**Proposal for Amendment 2 to UN GTR No. 9
(Pedestrian safety)**

Submitted by the Working Party on Passive Safety*

Amendment 2 to UN GTR No. 9 (Pedestrian Safety)

Figure 5, amend to read:

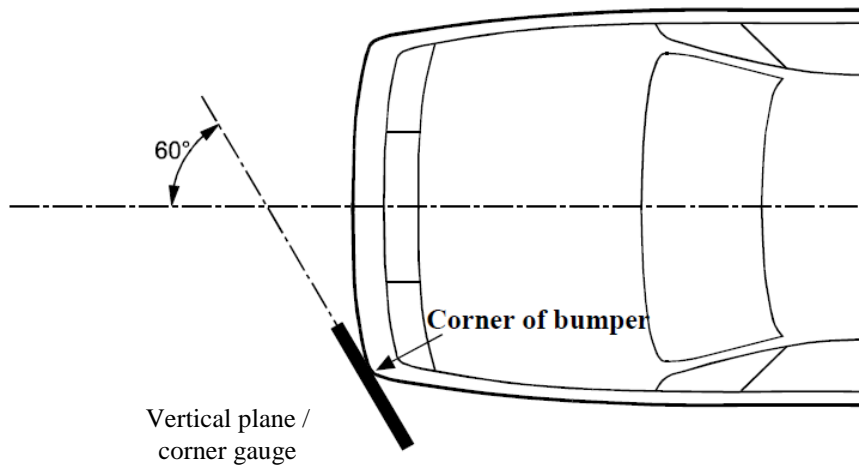
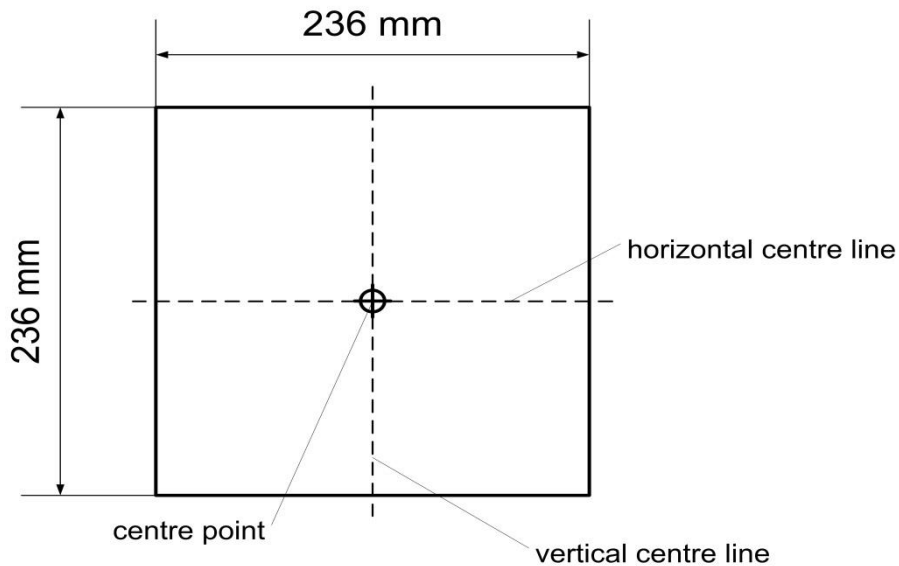
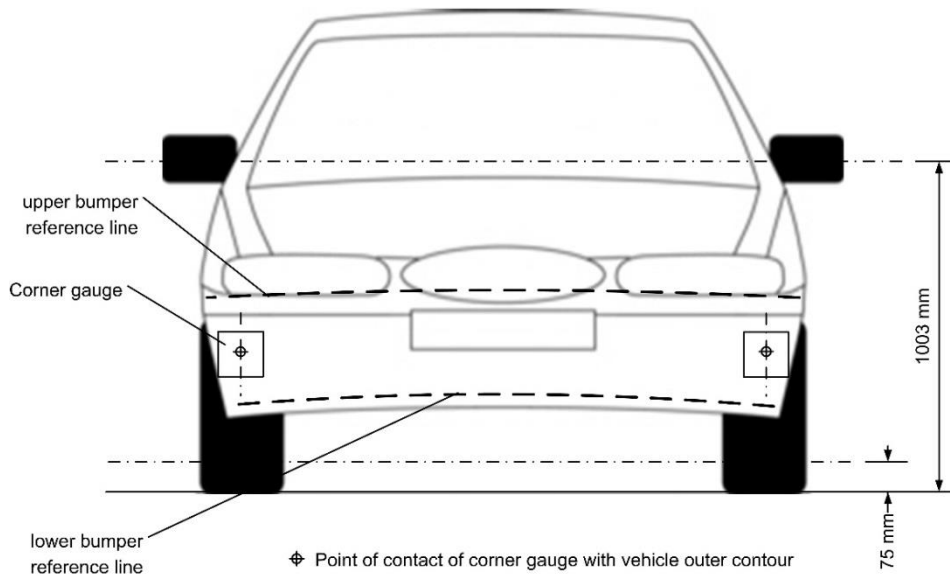
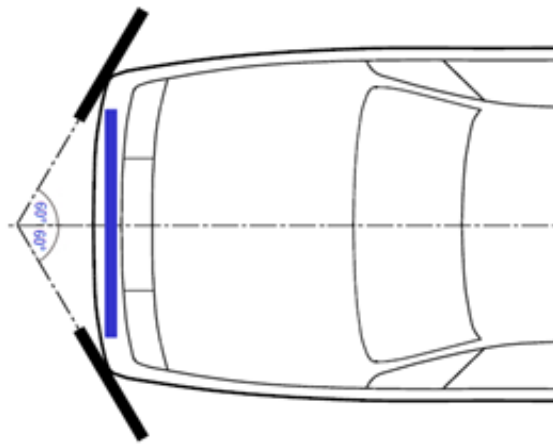
"3.14. "Corner of bumper" means the transversal position of the vehicle's point of contact with a corner gauge as defined in Figure 5B.

For determination of the corner of bumper, the front surface of the corner gauge is moved parallel to a vertical plane with an angle of 60° to the vertical longitudinal centre plane of the vehicle (see Figures 5A and 5C) at any height of the centre point of the corner gauge between:

- (a) Equal to and above the point found on the vertical line intersecting the Lower Bumper Reference Line at the assessment position in transversal direction or at 75 mm above the ground reference plane, whichever is higher.
- (b) Equal to and below the point found on the vertical line intersecting the Upper Bumper Reference Line at the assessment position in transversal direction or at 1,003 mm above the ground reference plane, whichever is lower.

"Figure 5A

Corner of bumper example (see paragraph 3.14., note that the corner gauge is to be moved in vertical and horizontal directions to enable contact with the outer contour /front fascia of the vehicle)

Figure 5C
Determination of the corner of bumper with the corner gauge (shown in random location)

Figure 5D
Determination of bumper test area (note that the corner gauges are to be moved in vertical and horizontal directions to enable contact with the outer contour/front fascia of the vehicle)

Insert new Figures 12 to 16, to read:

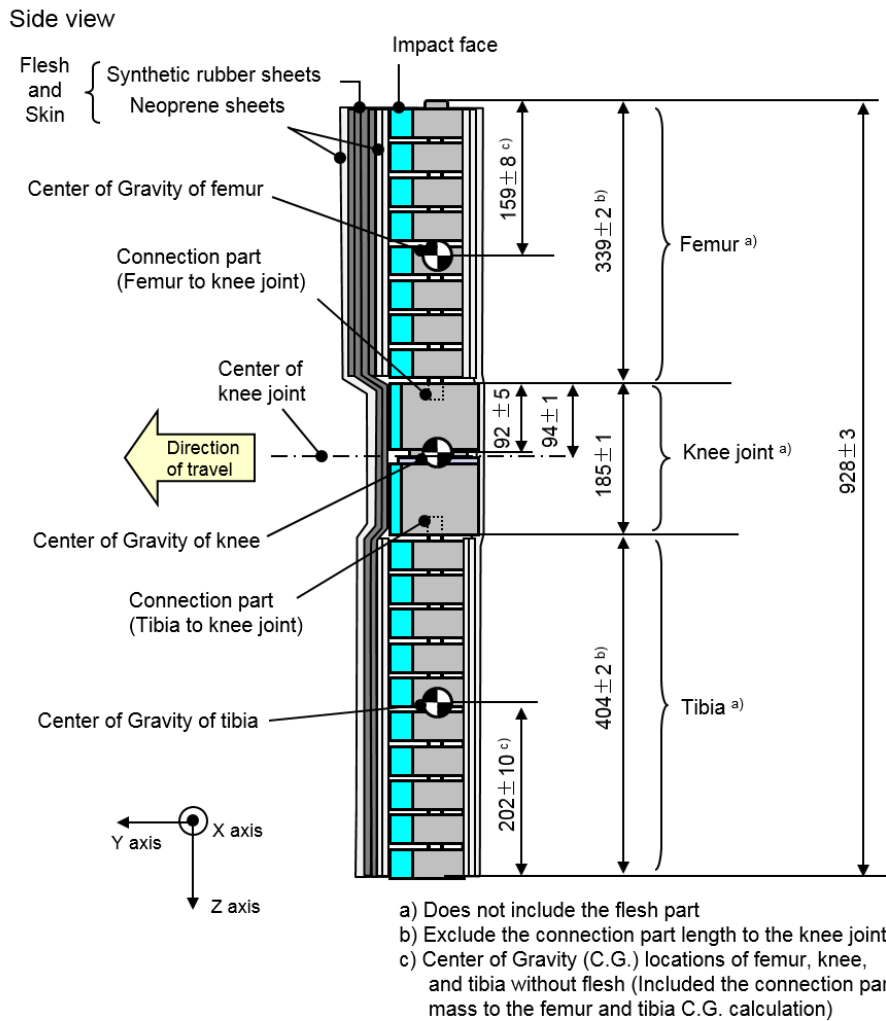
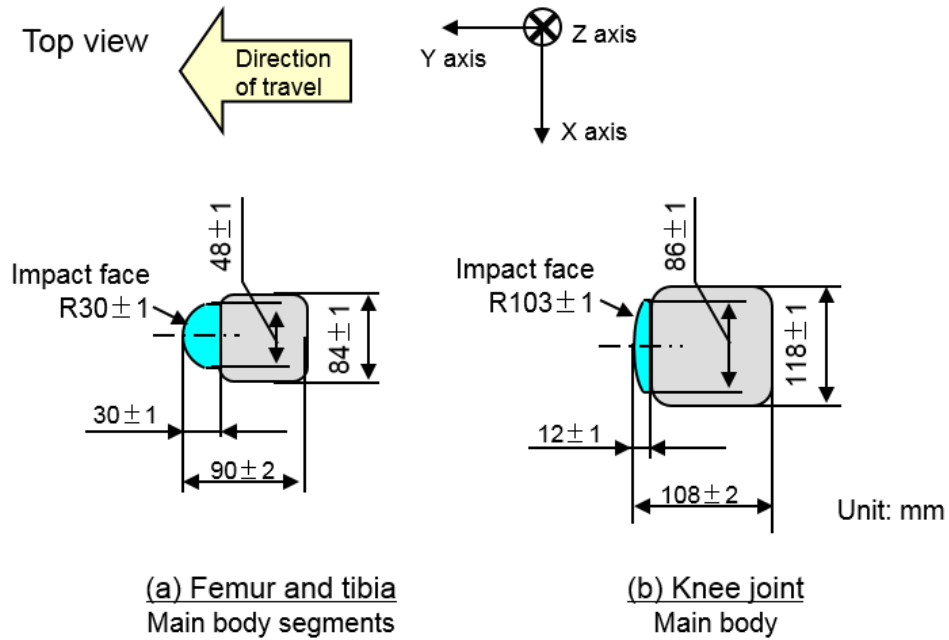
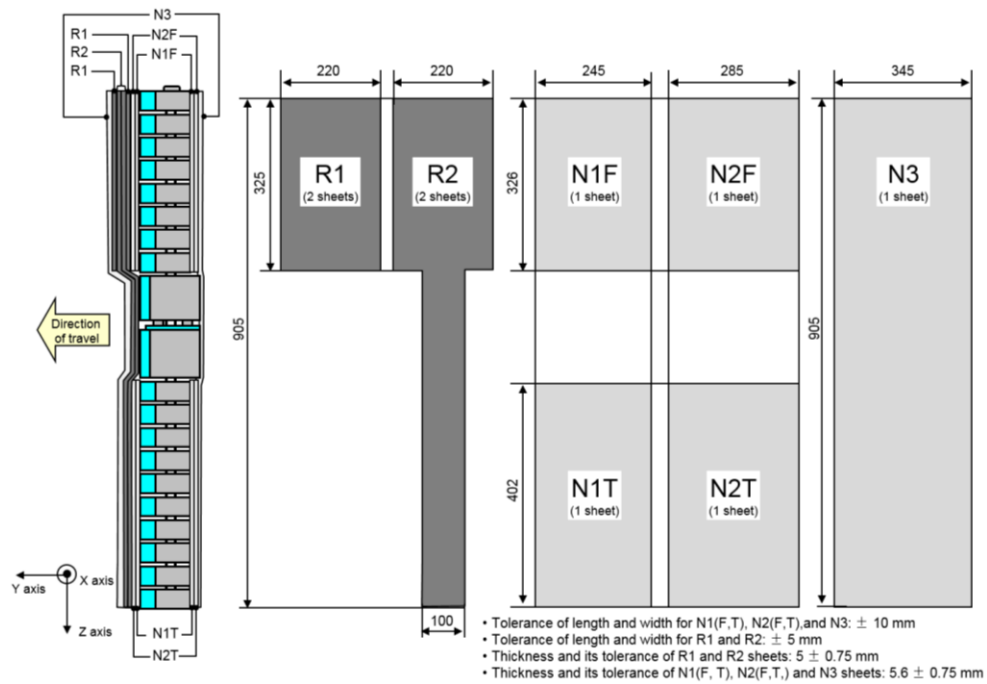
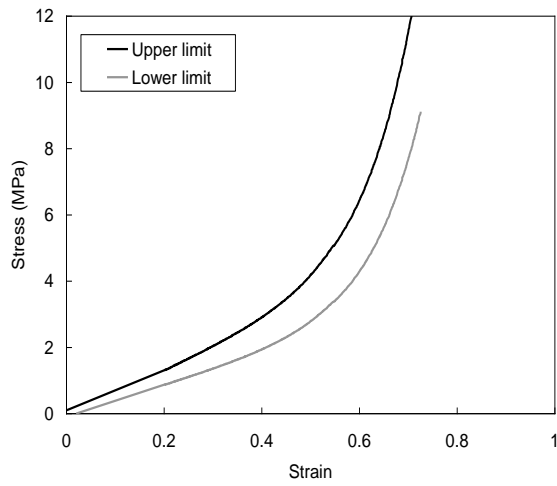
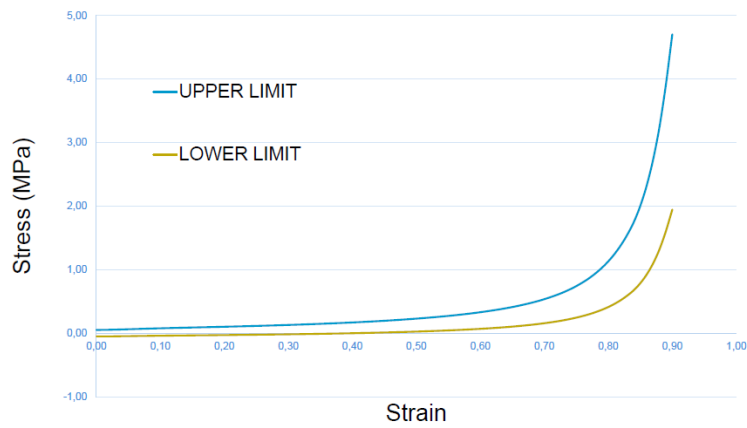
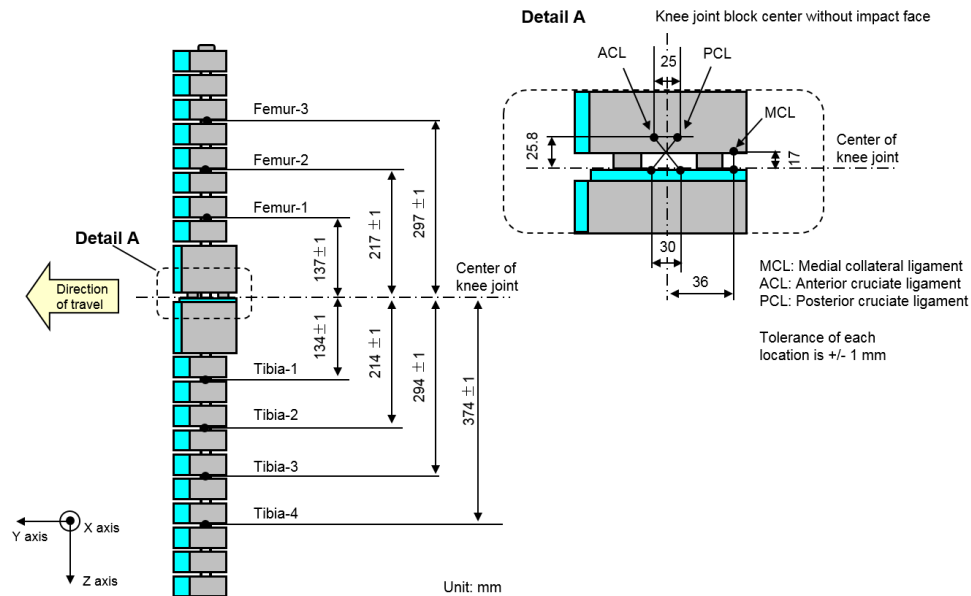
The flexible lower legform impactor shall consist of the flesh and skin, flexible long bone segments (representing femur bone and tibia bone), and the knee joint as shown in Figure 12.²

The assembled impactor shall have a total mass of 13.2 ± 0.4 kg. The dimensions of the fully assembled impactor shall be as defined in Figure 12, measured at the vertical centre line.

- "6.3.1.1.1. The cross-sectional shape of the femur main body segments, the tibia main body segments and their impact faces shall be as defined in Figure 13 (a).
- 6.3.1.1.2. The cross-sectional shape of the knee joint and its impact face shall be as defined in Figure 13 (b).
- 6.3.1.1.3. The masses of the femur and the tibia without the flesh and skin, including the connection parts to the knee joint, shall be 2.46 ± 0.12 kg and 2.64 ± 0.13 kg respectively. The mass of the knee joint without the flesh and skin shall be 4.28 ± 0.21 kg. The assembled mass of the femur, the knee joint and the tibia without the flesh and skin shall be 9.38 ± 0.3 kg. The screws that attach femur and tibia to the knee are part of the knee assembly.

The centres of gravity of the femur and tibia without the flesh and skin, including the connection parts to the knee joint, shall be as defined in Figure 12. The centre of gravity of the knee joint shall be as defined in Figure 12.

- 6.3.1.1.4. For each test, the impactor (femur, knee joint and tibia without flesh and skin) shall be covered by the flesh and skin composed of synthetic rubber sheets (R1, R2) and foamed neoprene sheets (N1F, N2F, N1T, N2T, N3) as shown in Figure 14. The size of the sheets shall be within the requirements described in Figure 14. The sheets are required to have compression characteristics as shown in Figure 15. The compression characteristics shall be checked using material from the same batch as the sheets used for the impactor flesh and skin.

"Figure 12
Flexible lower legform impactor: Dimensions and centre of gravity locations of femur, knee joint and tibia (side view)

Figure 13
Flexible lower legform impactor: Schematic plan views of femur, tibia, and knee dimensions (top view, main body segments)

Figure 14
Flexible lower legform impactor: Flesh and skin dimensions

Figure 15
Flexible lower legform impactor: Flesh and skin compression characteristics

Figure 16
Flexible lower legform impactor: Location of the transducers

Figures 16 and 17 (former), renumber as Figures 20 and 21 and amend to read:

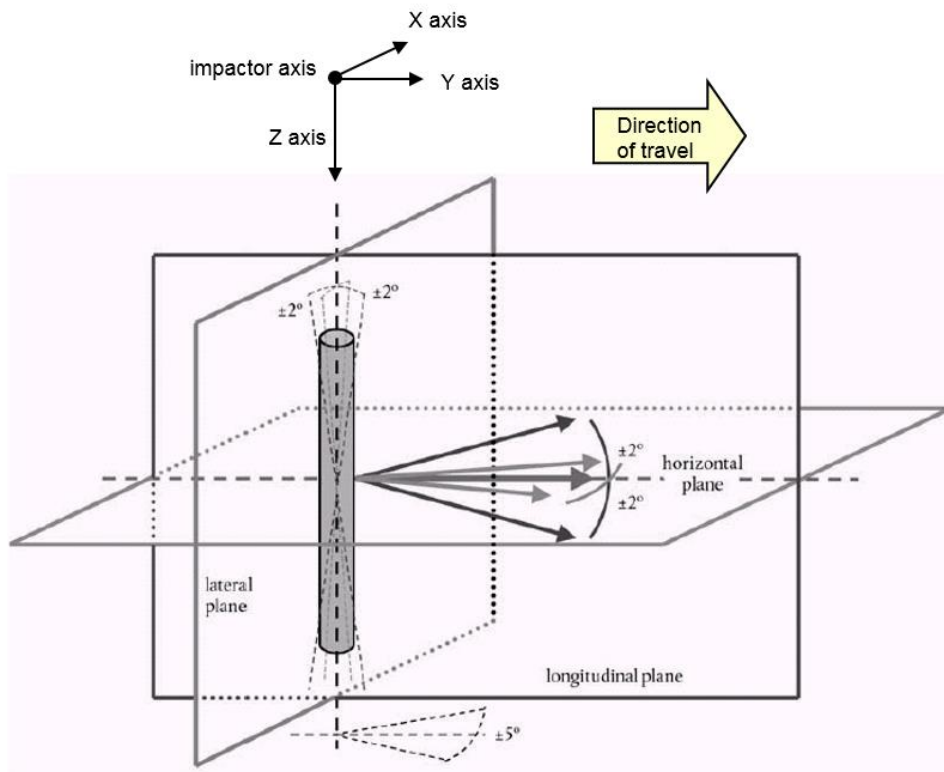
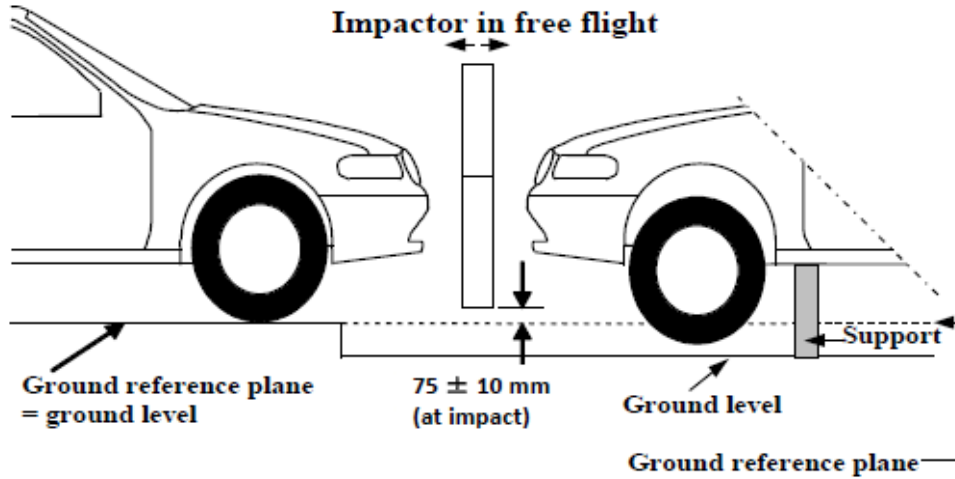
7.1.1.2. The direction of the impact velocity vector shall be in the horizontal plane and parallel to the longitudinal vertical plane of the vehicle. The tolerance for the direction of the velocity vector in the horizontal plane and in the longitudinal plane shall be $\pm 2^\circ$ at the time of first contact. The axis of the impactor shall be perpendicular to the horizontal plane, with a roll and pitch angle tolerance of $\pm 2^\circ$ in the lateral and longitudinal plane. The horizontal, longitudinal and lateral planes are orthogonal to each other (see Figure 20).

7.1.1.3. The bottom of the impactor (without parts needed for the purposes of launching and/or protection) shall be 75 mm above the ground reference plane at the time of the first contact with the bumper (see Figure 21), with a tolerance of ± 10 mm. When setting the height of the propulsion system, an allowance shall be made for the influence of gravity during the period of free flight of the impactor.

7.1.1.3.2. At the time of first contact the impactor shall have the intended orientation about its vertical axis, for the correct operation of its knee joint, with a yaw angle tolerance of $\pm 5^\circ$ (see Figure 20)."

"Figure 20
Tolerances of angles for the flexible lower legform impactor at the time of the first impact.....

Figure 21
Flexible lower legform impactor to bumper tests for complete vehicle in normal ride attitude (left) and for cut-body mounted on supports (right) (see paragraph 7.1.1.3.)

Figure 22
Flexible lower legform impactor: Requirement corridors of the femur and the tibia, without flesh and skin, in the static certification test (see paragraph 8.1.1.2.)

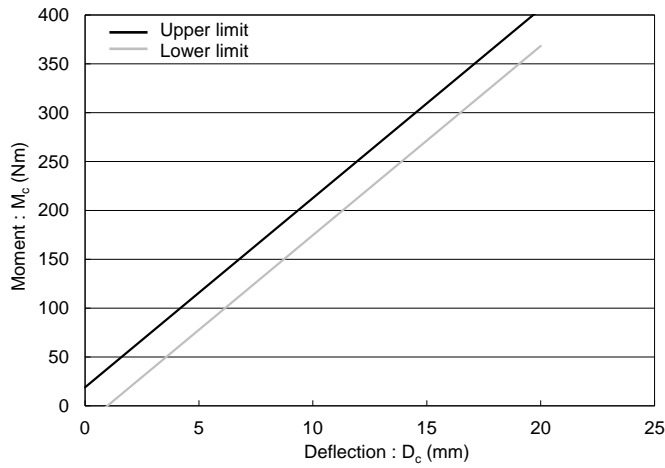
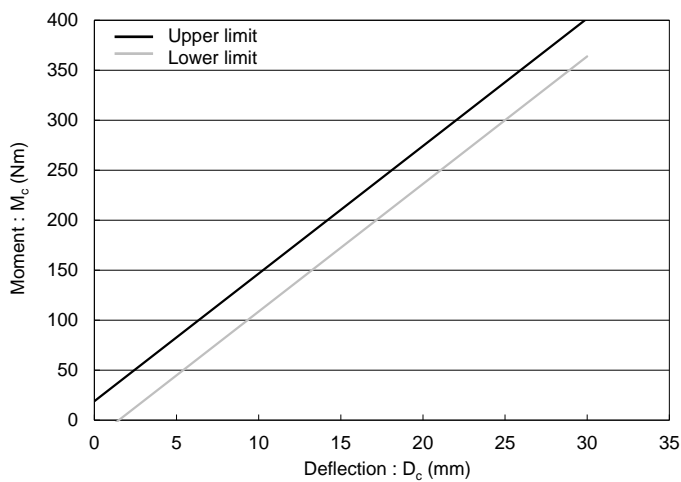
- 8.1.1.2. When the femur and the tibia of the impactor, without flesh and skin, are loaded in bending in accordance with paragraph 8.1.1.4., the applied moment and the generated deflection at the centre of the femur and the tibia (M_c and D_c) shall be within the corridors shown in Figure 22.

Figure 23
Flexible lower legform impactor: Requirement corridors for the knee joint, without flesh and skin, in the static certification test (see paragraph 8.1.1.3.)

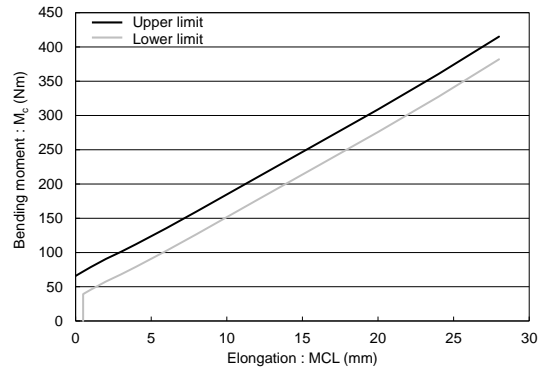
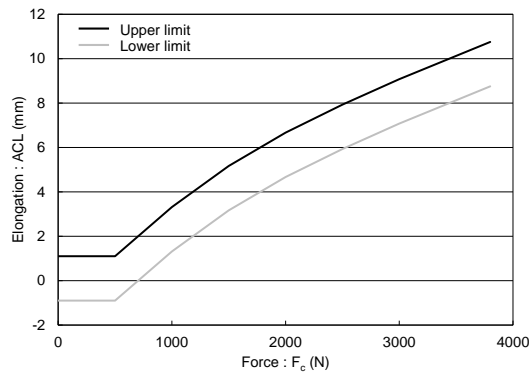
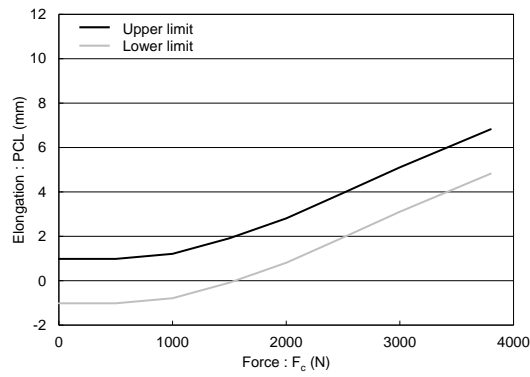
- 8.1.1.3. When the knee joint of the impactor, without flesh and skin, is loaded in bending in accordance with paragraph 8.1.1.5., the MCL, ACL, and PCL elongations and applied bending moment or the force at the centre of the knee joint (M_c or F_c) shall be within the corridors shown in Figure 23.

Figure 24
Flexible lower legform impactor: Test set-up for the femur in the static certification test (see paragraph 8.1.1.4.)

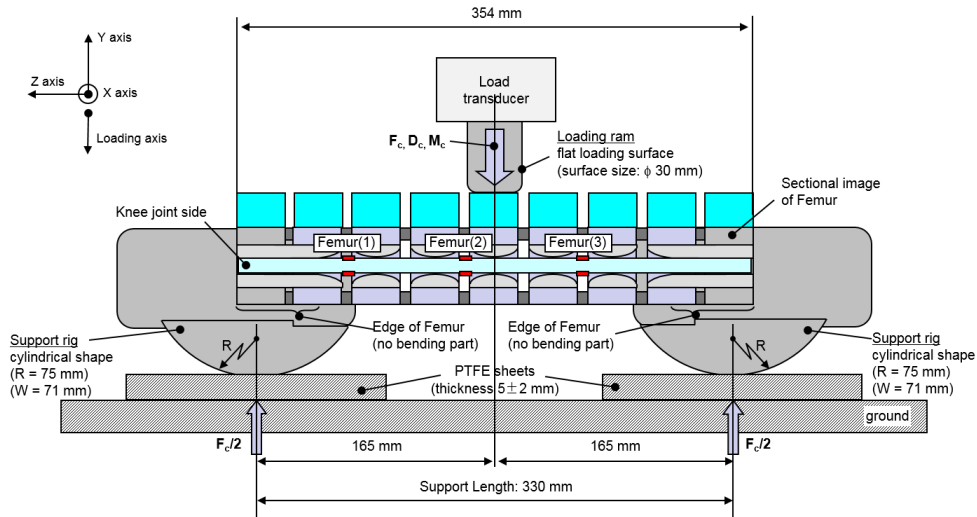
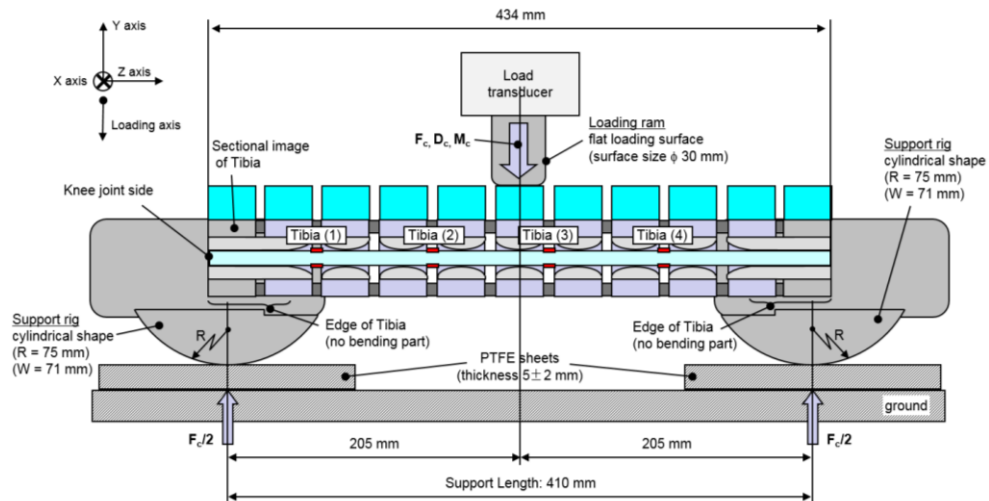
- 8.1.1.4. The edges of the femur and tibia, without flesh and skin, not bending parts, shall be mounted to the support rig firmly as shown in Figure 24 and Figure 25. The Y-axis of the impactor shall be parallel to the loading axis within $180 \pm 2^\circ$ tolerance. To obtain repeatable loading, low friction Polytetrafluoroethylene (PTFE) plastic pads are used under each support (see Figures 24 and 25).

Figure 26
Flexible lower legform impactor: Test set-up for the knee joint in the static certification test (see paragraph 8.1.1.5.)

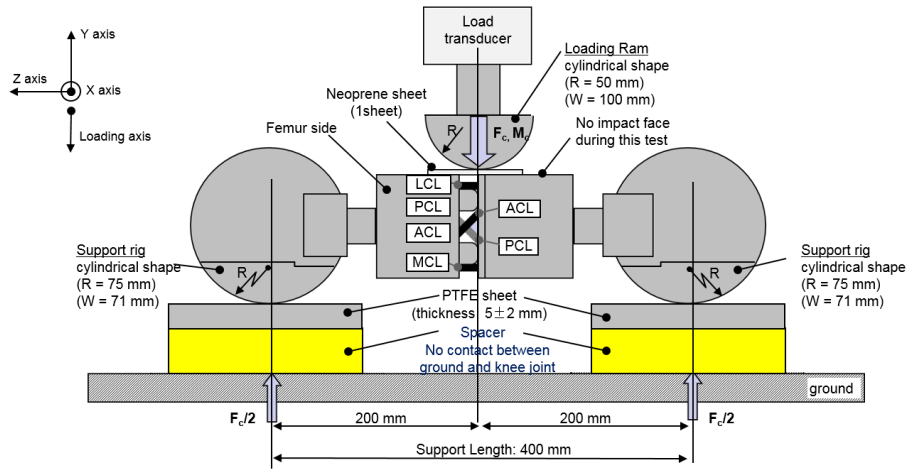
- 8.1.1.5. The ends of the knee joint, without flesh and skin, shall be mounted to the support rig firmly as shown in Figure 26. The Y-axis of the impactor shall be parallel to the loading axis within $\pm 2^\circ$ tolerance. To obtain repeatable loading, low friction Polytetrafluoroethylene (PTFE) plastic pads are used under each support (see Figure 26). To avoid impactor damage, a foamed neoprene sheet shall be set between the loading ram and the impactor face of the knee joint, which is described in Figure 26, shall be removed. The foamed neoprene sheet used in this test shall have compression characteristics as shown in Figure 15.

- The centre of the loading force shall be applied at the knee joint centre within $\pm 2^\circ$ mm tolerance along the Z-axis (see Figure 12). The external load shall be increased so as to maintain a deflection rate between 10 and 100 mm/minute until the bending moment at the centre part of the knee joint (M_c) reaches 400 Nm.
